STAFF'S  
REQUEST ANALYSIS  
AND  
RECOMMENDATION

03TS0199

Watermill Properties  
(Watermill – Phase IV)

Clover Hill District  
Watermill Subdivision Phase IV

03TS0199-1

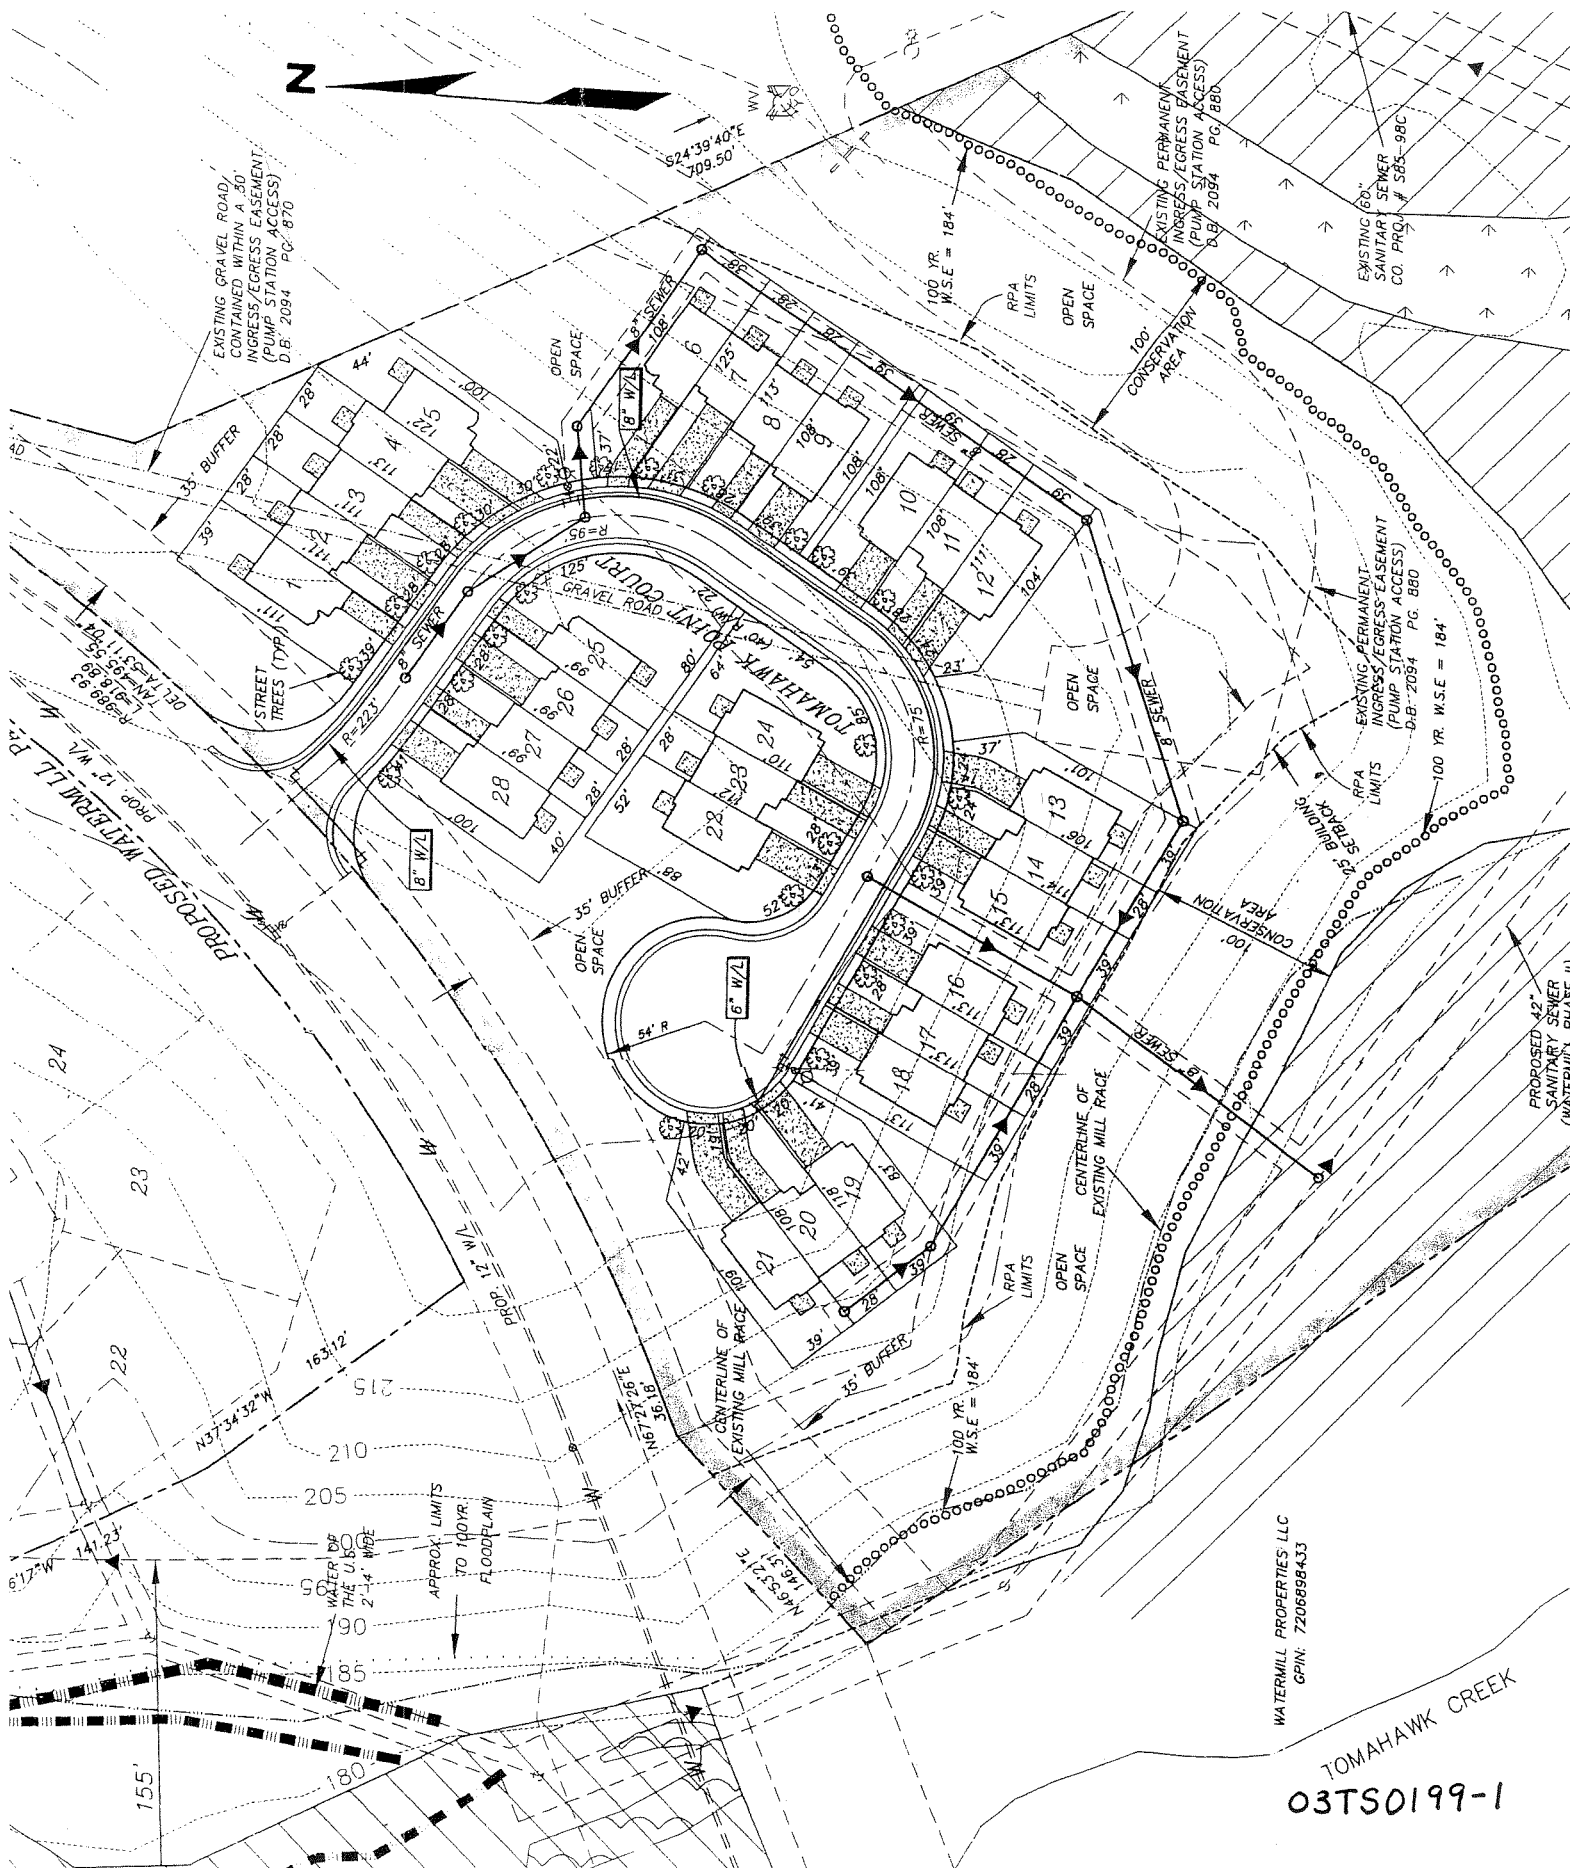
REQUEST: Watermill Properties requests Planning Commission approval of the tentative subdivision plat to allow the required recreational area to lie outside the limits of the subdivision.

1. This section of the Watermill Subdivision has a total of twenty-eight (28) lots and will not produce a development of a viable size to independently support a recreation area with any facilities other than possibly a small play structure.
2. The subdivision will be connected by a pedestrian pathway to the existing recreation complex that will have both free and fee based community recreation facilities.

10. The storm drainage design for Tomahawk Point Court and as much of the dwelling unit areas as is practicable shall stipulate an outfall location such that the existing mill race can be utilized as end of pipe treatment. (EE)

14. Left and right turn lanes shall be constructed on Watermill Parkway in conjunction with construction of Tomahawk Point Drive. (T)
15. Existing ingress and egress easements for the Chesterfield County pump station facilities shall be shown on the construction plans with a narrative detailing the proposed method of maintaining access to County facilities shown on the tentative plan. (T, U)
